Applicant: Julie Long; City of Bloomington
Consultant:
Project: Jones Place Outfall Maintenance
Location: 2531 Jones Place: Bloomington
Rule(s): 2, 7 and 8
Reviewer(s): LLH and BCO

General Background & Comments

RIP RAP SWALE - PROFILE

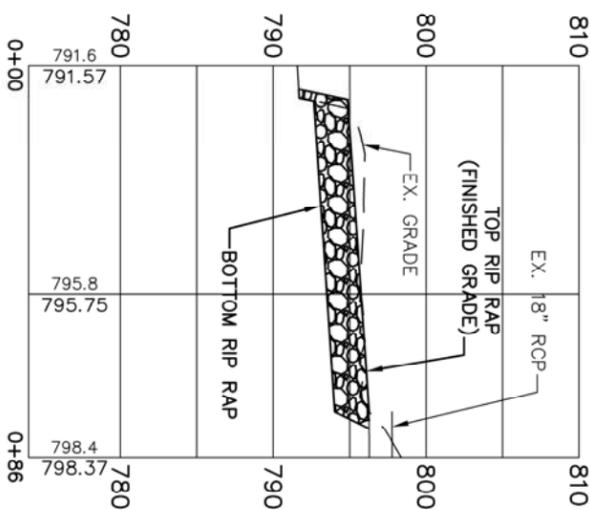
The project proposes the use of Class III fieldstone riprap, which has an average diameter size of 30-inches. The objective is to maintain the natural characteristics of the creek system yet provide for a stable slope that forms the creek bank.

Filter material used will be 9-inches in depth. Toe boulders will not be used.

The District's Atlas 14 100-year high water elevation at this location is 799.9 M.S.L., approximately the top of the bank. The riprap will extend to the storm sewer outfall, approximately 797 M.S.L.

1. General Conditions
2. Per Rules 2.4.1 and 2.4.2, site plans identifying existing and proposed elevation contours of the work area, and the District’s Atlas 14 100-year frequency floodplain elevation for Nine Mile Creek on the site, elevation 799.9 M.S.L.
3. Per Rules 7.3.2b and d, plans showing an appropriate geotextile filter fabric must be placed and conform to standard Minnesota Department of Transportation specifications.
4. Per Rule 7.3.3, plans identifying the finished slope of the shoreline, which must not be steeper than 3:1 (horizontal to vertical).
5. Per Rule 7.4.2b, plans identifying materials to be used, including the size (thickness) of riprap to be used.

RIP RAP SWALE - DETAIL

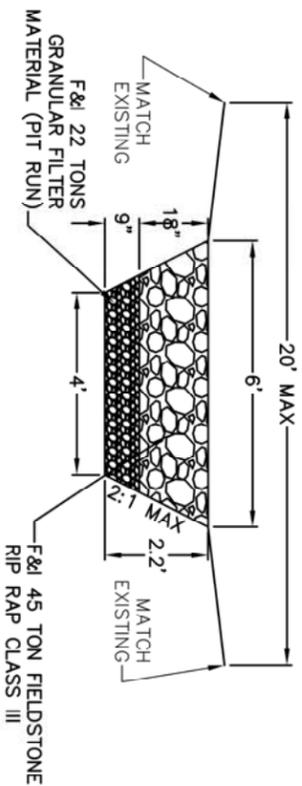
At the location of the proposed outfall channel, the area will be over excavated allowing 28 cubic yards of riprap and 12 cubic yards of granular filter material to be placed at an elevation that matches the pre-project grade.
